AG-SB-2016-04-C-EN – Replacement Muffler Tube Cavalon and Calidus

Category C

This Service Bulletin is applicable for all Cavalon and Calidus, engine type 914 UL, where the rivets are fitted at the hot end of the mufflers.

Fig.8: Installation of locking wire

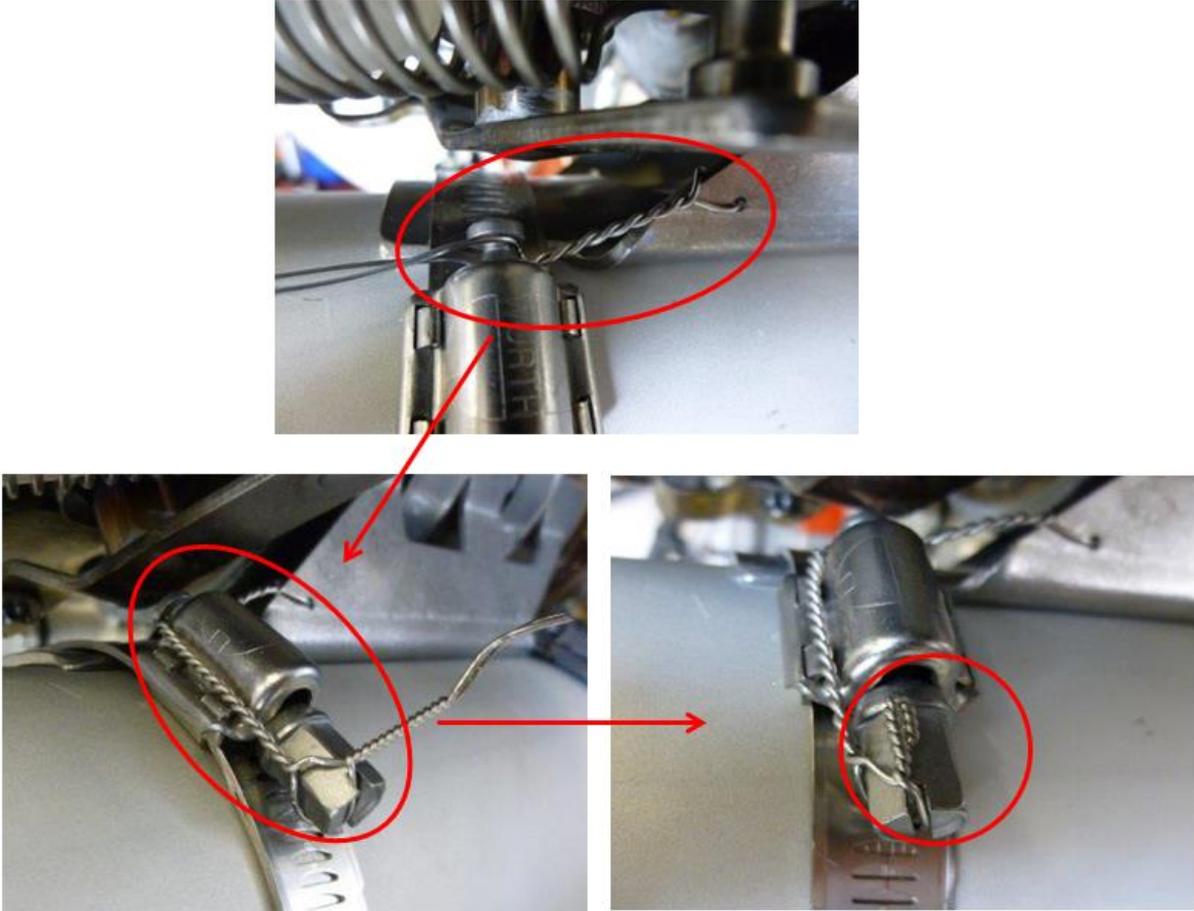
- 15 Fix the bottom cowling according to chapter 52-00-00 4-1. Make sure that the pipe of muffler tube is placed in the middle opening (surrounding 15 mm). If necessary, adjust the position of the muffler tube (Fig.7).
- 16 Remove the bottom cowling and tighten the two hose clamps and hinge pin clamp.
- 17 Secure the screws of hose clamps with locking wire (Fig.8).
- 18 Install the cowling according to chapter 52-00-00 4-1.
